BULLETIN CT-01

Date: September 1st, 2022	Number: CT-1	Project #: 21162
Project Name: Piper Remodel	Attached: REV2 structural drawings (Delta 2 – Bulletin CT-1)	
Number of Pages: 17

Subject: Grade beam revisions
Main Floor framing revisions
Main Floor sheathing addition (thickness and nailing)

Drawings affected: S2.0, S2.1

E2 TYPICAL 2×6 INFILL BETWEEN $4 \times 4 \times 2 \times 1/4$

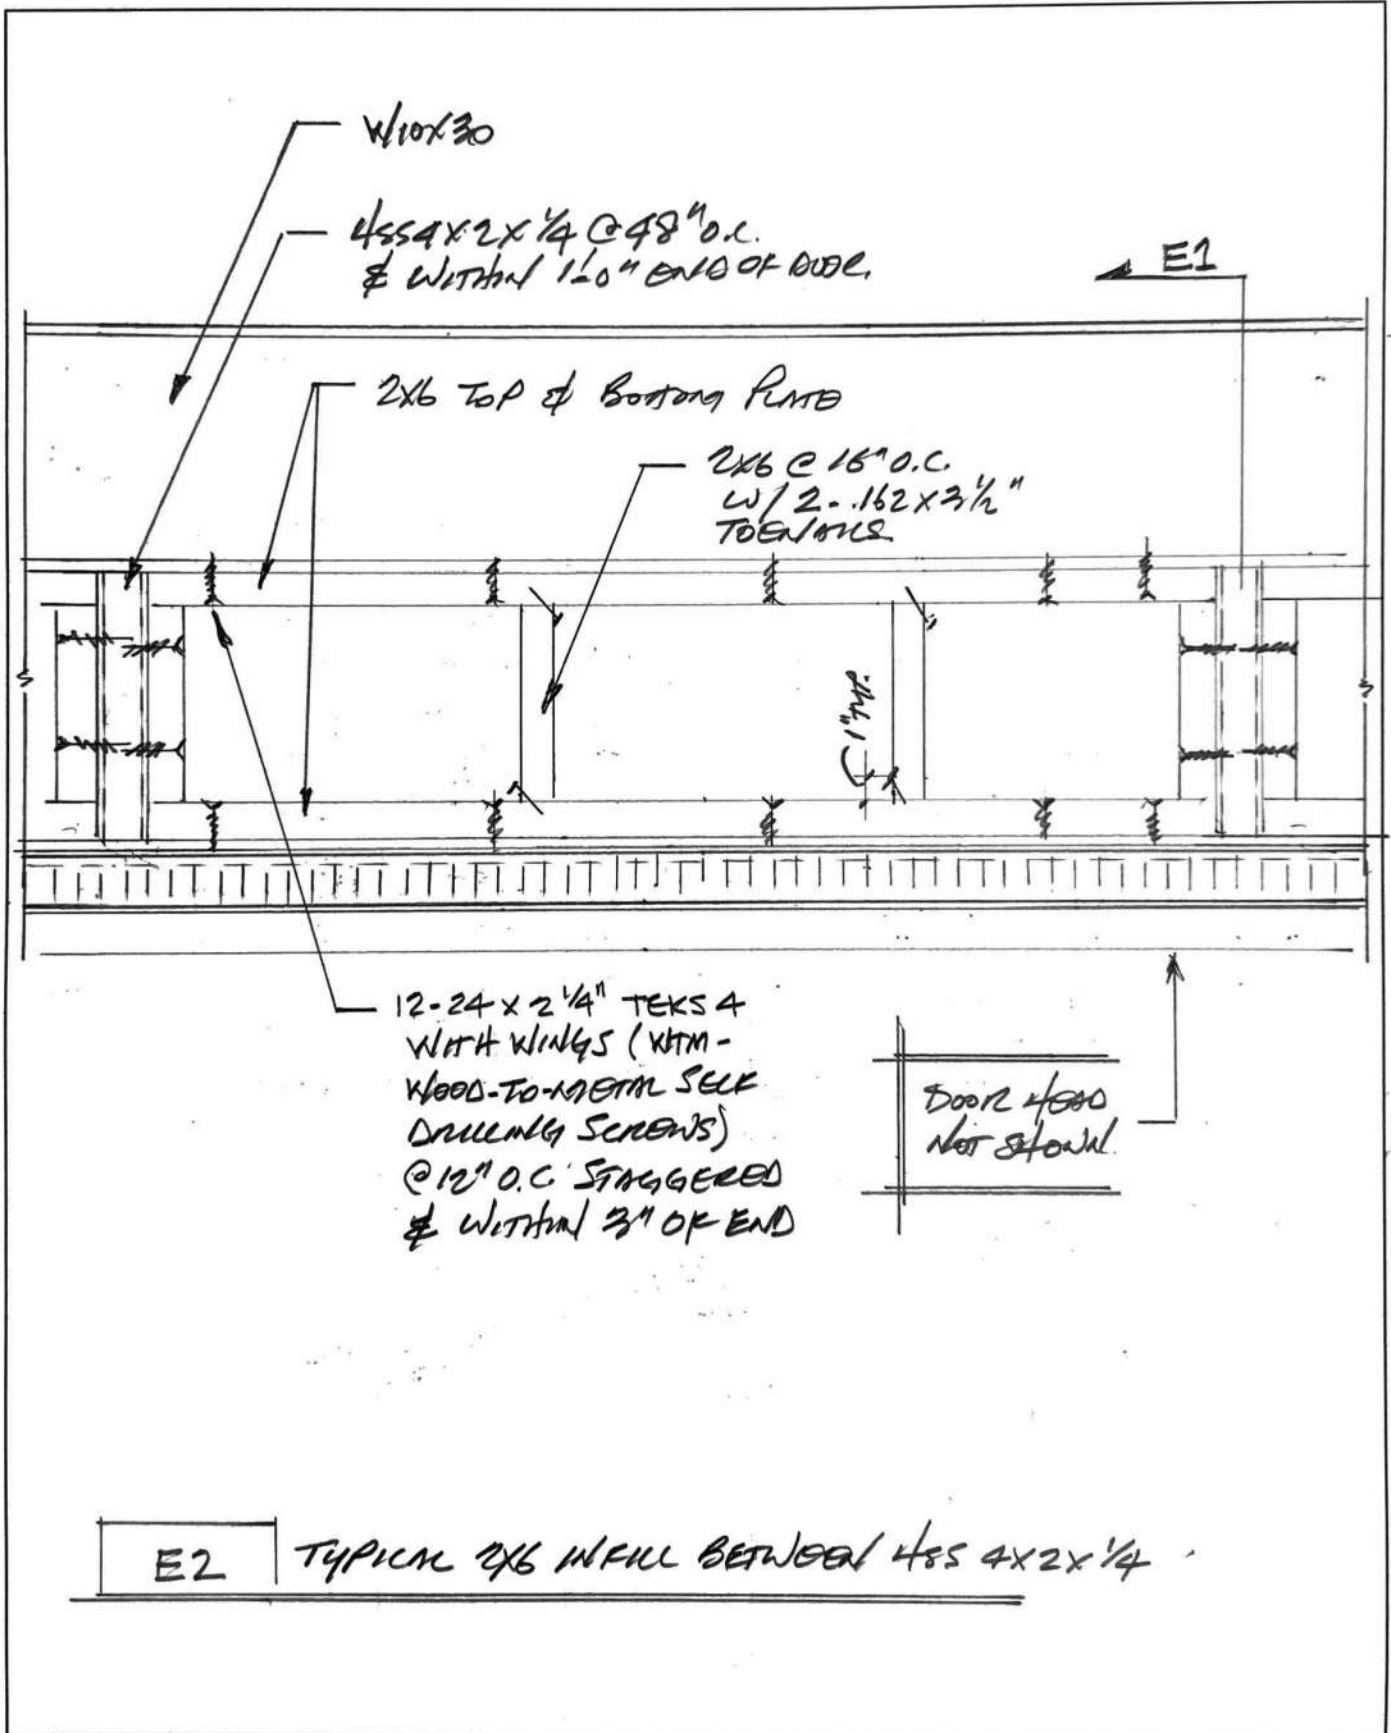
Sketch E1 and E2 provide direction associated with the slip track above the new deck door. See email attached Todd Beasley with Clark Dietrich who has confirmed that they can make the slip track with a 5 1/2” web to match wood framed construction. We assume that this is a special-order item so encourage ordering of this component early. Please also see attached wood-to-metal screws with wings for attaching the infill wood framing. Understanding and constructing this slip track assembly correctly is key to protecting the door head from being loaded when the roof supports snow load. Please note that no drywall, plywood or finish materials will attach below the 3/8” steel plate. Exterior finishes should allow for a minimum of 1/2” space between the top of the head and bottom of the finish component. Please reach out to me if you have any questions regarding this connection.

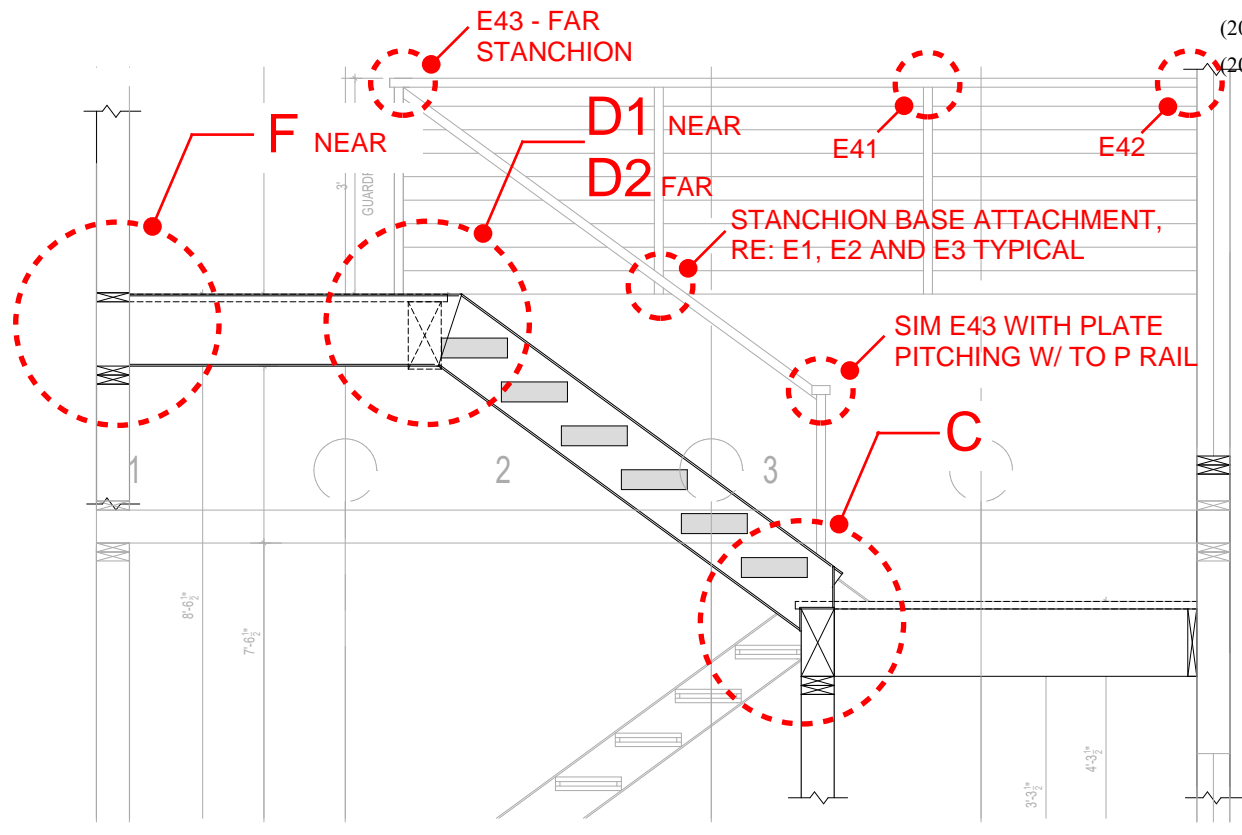
STRUCTURALLY ACCEPTABLE TO REMOVE THIS PORTION OF CONCRETE SETM PROVIDED IT IS SAW CUT. VERIFY ANCHOR BOLTS AT REMAINING WALL HAVE 1 1/2" COVER.

Please find photo showing existing concrete curb with structural approval to remove.
